## 2 SITE CHARACTERISTICS

### 2.4 Hydrologic Engineering

**Figure 2.4.1-2. Site Area Topography and Drainage**

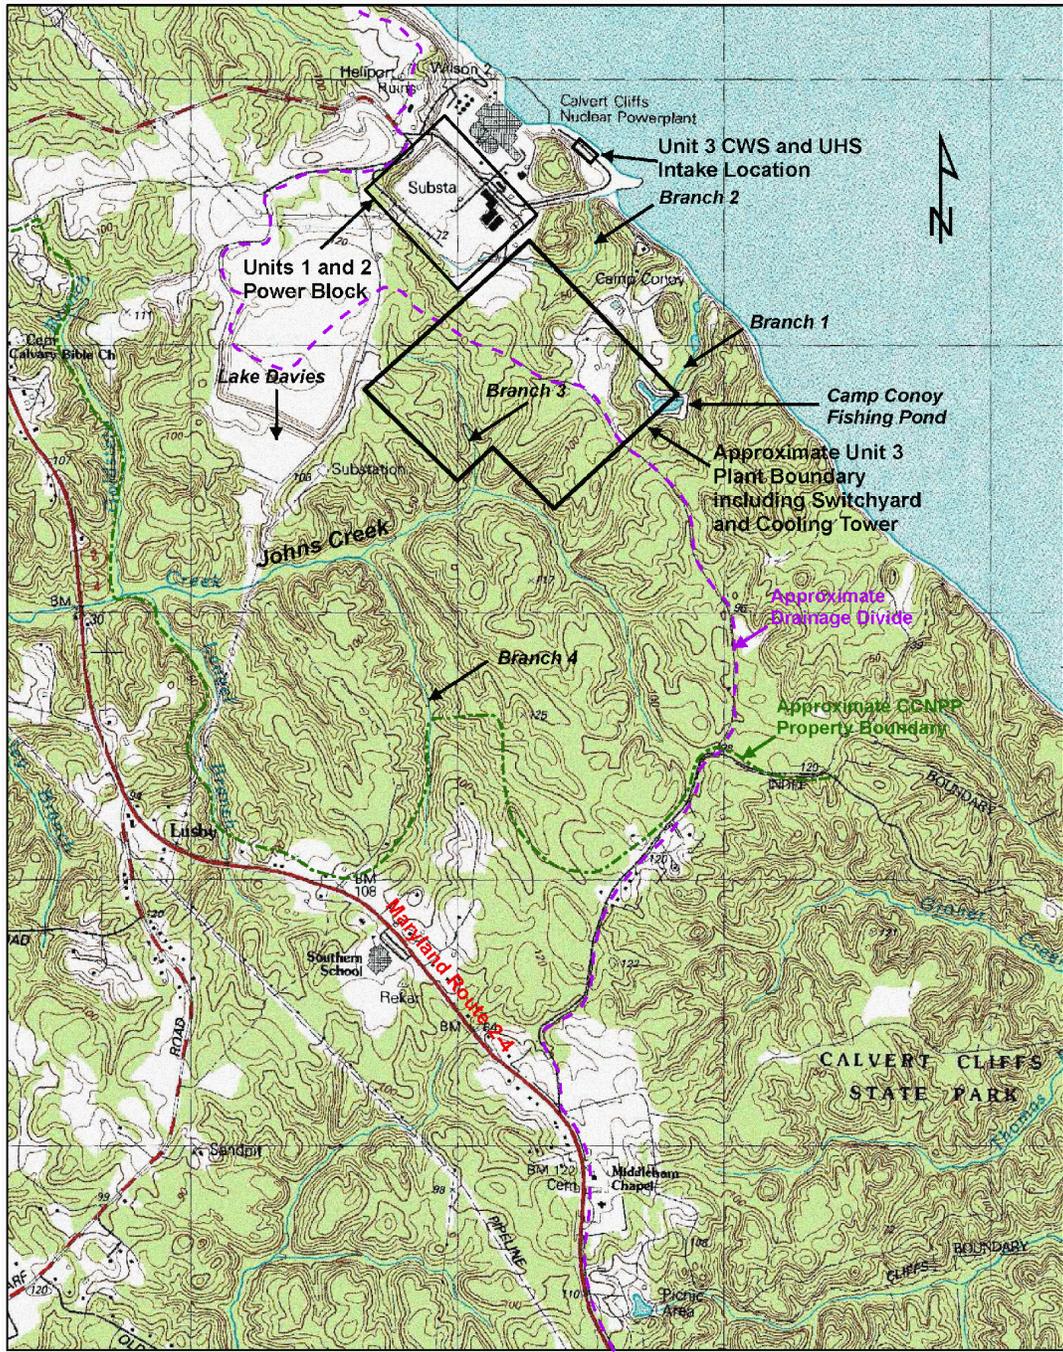
Note that the CCNPP Unit 3 site boundary shown on this figure differs from those shown on other figures of Section 2.4 of this report. This difference exists in the source COL FSAR figures as well. In RAI 400, Question 02.04-1, the staff requested that the COL applicant clarify

the site boundary associated with this figure. RAI 400, Question 02.04-1is being tracked as an open item. (Source: COL FSAR Figure 2.4-1)

**Figure 2.4.12-1.** Monthly Groundwater Gradient Estimated between Observation Wells OW-301 and OW-703A in the Upper Chesapeake Unit and OW-423 and OW-752A in the Surficial Aquifer

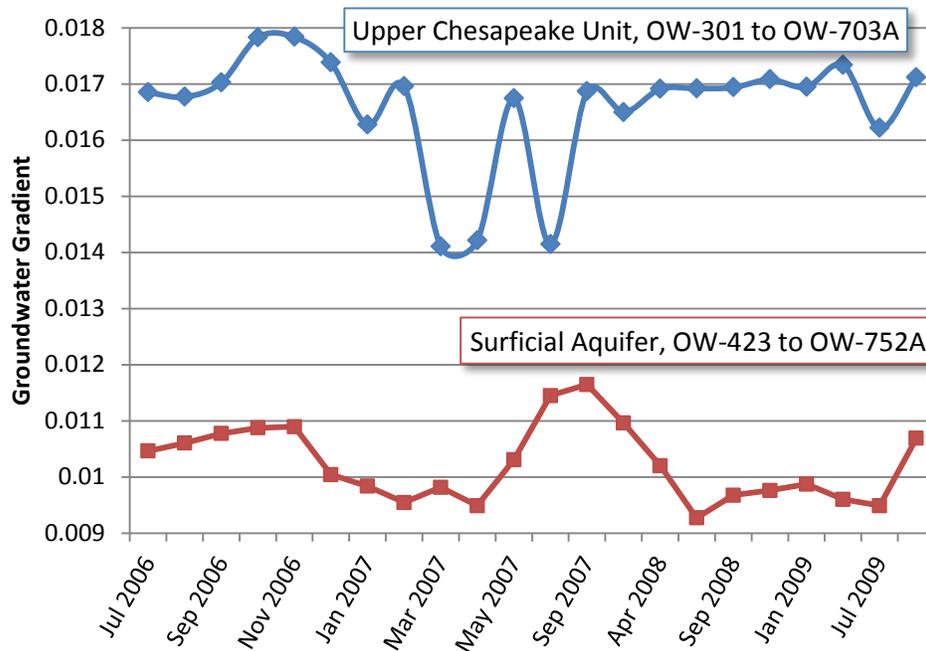
In RAI 101, Question 02.04.12-6, the staff requested that the COL applicant provide a discussion of the potential effect of temporal variability in head on the estimated groundwater velocities and travel times. In a June 12, 2009, response to RAI 101, Question 02.04.12-6, the COL applicant provided estimates of the variability in horizontal hydraulic gradient over the period of head measurements by examining the gradients in the surficial aquifer and the Upper and Lower Chesapeake units during a month of high head and a month of low head in each unit. The COL applicant reported that the hydraulic gradient varied from 0.01 to 0.0104 in the surficial aquifer, from 0.0144 to 0.0174 in the Upper Chesapeake unit, and from 0.0115 to 0.0152 in the Lower Chesapeake unit. The staff evaluated the temporal variability of the horizontal groundwater gradient in the surficial aquifer for the period of observations from July 2006 to October 2009, and noted a somewhat greater variability in gradients than reported by the COL applicant. The gradient calculated by the staff in the surficial aquifer using observed heads at wells OW-423 and OW-752A varied from 0.0093 to 0.0116, as shown below in Figure 2.4.12-1. The monthly horizontal groundwater gradient in the Upper Chesapeake unit was calculated by staff using observed heads at well OW-301 (at the CCNPP Unit 3 Reactor Building location) and well OW-703A (located to the north, near Branch 2), which corresponds to one of the subsurface transport pathways analyzed in COL FSAR Section 2.4.13. The observed groundwater gradient between these wells varied from 0.0141 to 0.0178, as shown in Figure 2.4.12-1.

The staff evaluated the CCNPP Unit 3 site groundwater hydraulic head data and the associated contour maps of head in the surficial aquifer and the Upper and Lower Chesapeake units presented in the COL FSAR. The staff finds the contour maps consistent with the site data and appropriate for evaluating subsurface pathways at the CCNPP Unit 3 site. The staff finds the COL applicant’s June 12, 2009, response to RAI 101, Question 02.04.12-6, acceptable. Accordingly, the staff considers RAI 101, Question 02.04.12-6 resolved.
